# BOARDS & COMMISSIONS APPLICATION

Application Number 225-19

## **Z25-19** **Sunoco Signs**

Property Owner: H & K Sarai Inc.  
Applicant: Sarah Mheisen  
Location: 427 North Court Street  
Zoning: M-U (Multi-Use)  
Request: Sign Variance to Section 1147.07(a) to allow a ground sign with the required setback, Section 1147.07(b)(4) to allow an internally illuminated sign, Section 1147.07(j) to allow a prohibited electronic message center sign, Section 1147.10(d) to allow a prohibited pole sign, Section 1147.10(f) to allow a prohibited rooftop sign, Section 1147.13(b) to allow a ground sign larger and taller than permitted, and Section 1147.13(c) to allow both ground signs and building signs

## Proposed Option 1 - Panel Replacement

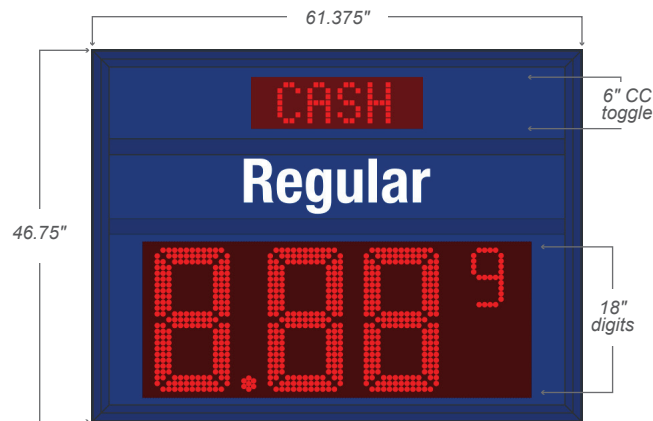
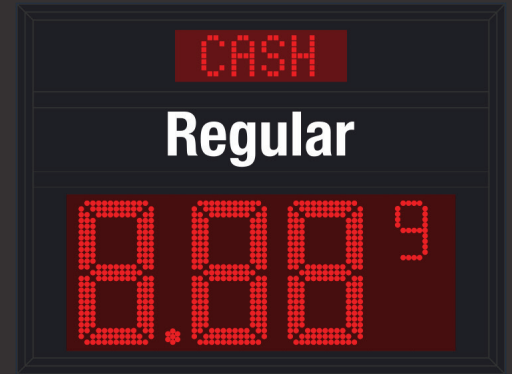
Ground Sign Option 1 is a panel replacement that does not change the dimensions, height, or location of the sign. A nonconforming sign may be serviced and maintained, including a panel replacement. Therefore, the only variance applicable to Option 1 is Section 1147.13(c) to allow both ground signs and building signs.

## Ultra Image Gas Canopy

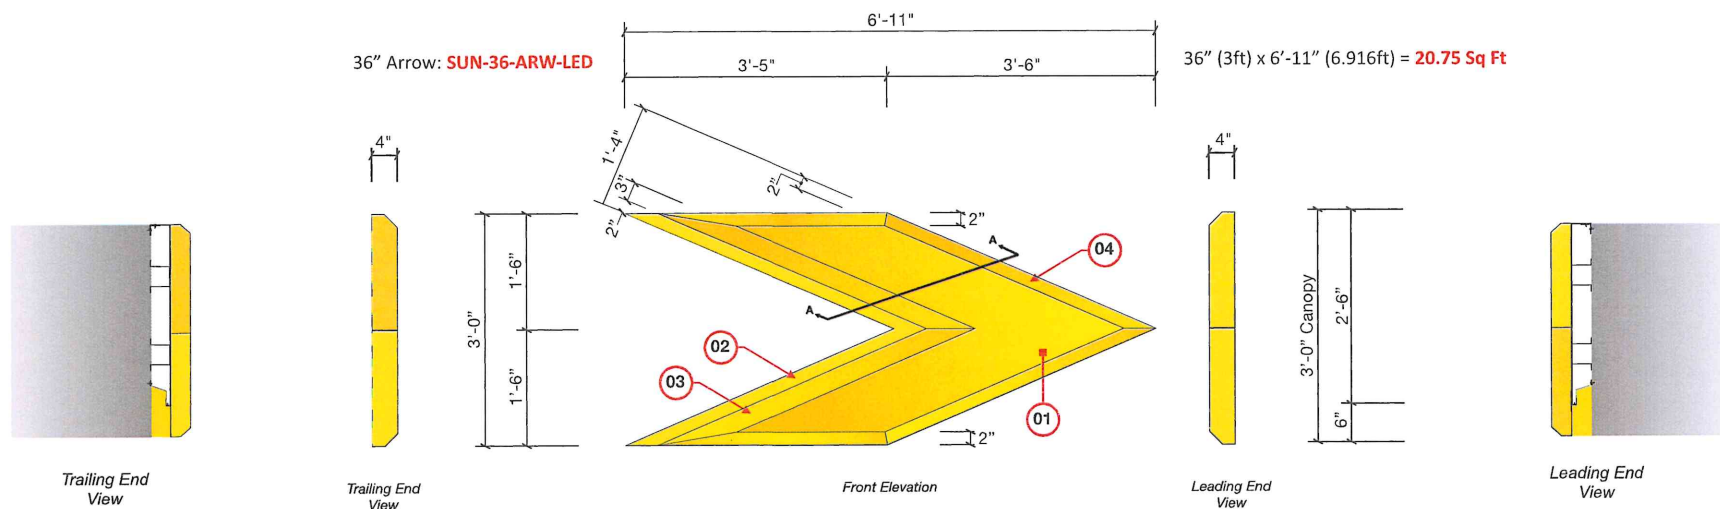
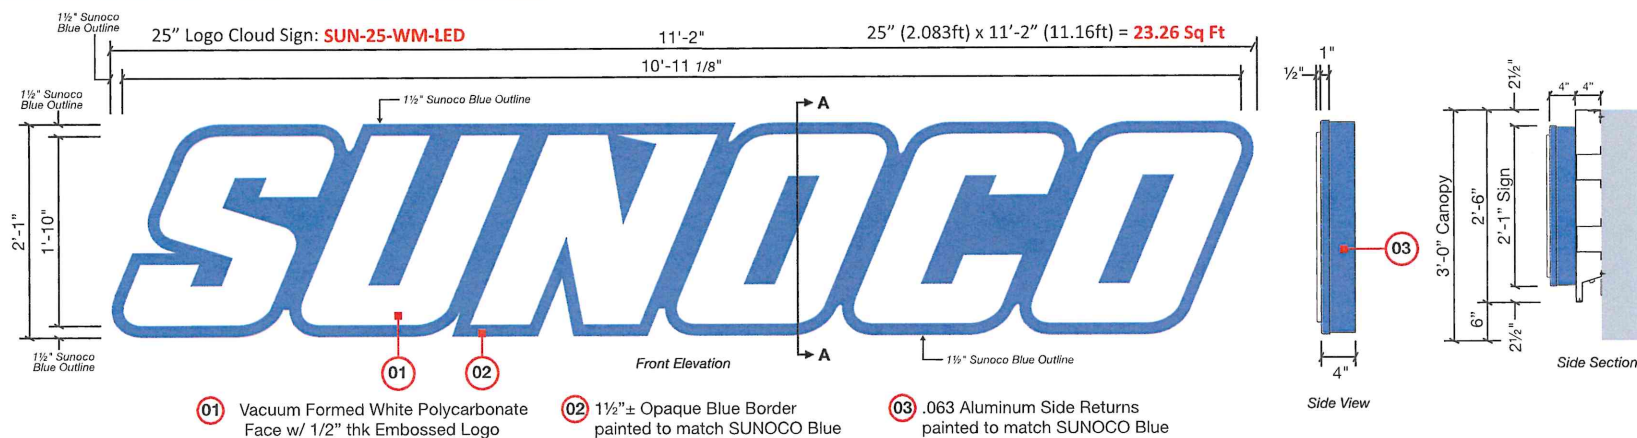
Section 1147.10(f) states that rooftop signs are prohibited. The 9 sq. ft. wall sign on the south side of the canopy projects 6 in. above the canopy. The projection above the canopy is considered a “rooftop sign” and is prohibited.

Section 1145.13(c) states that in lieu of one permanent ground sign, one wall sign is permitted on the primary frontage, a maximum of 12 sq. ft. in area, and one wall sign is permitted on the secondary frontage, a maximum of 6 sq. ft. in area. The north and south sides of the canopy are considered frontages as they serve as vehicular entrances and the north side of the canopy faces West Union Street.

The proposed wall signs and either Ground Sign Option 1 and Option 2 do not meet Section 1145.13(c) as both a ground sign and wall signs are proposed.
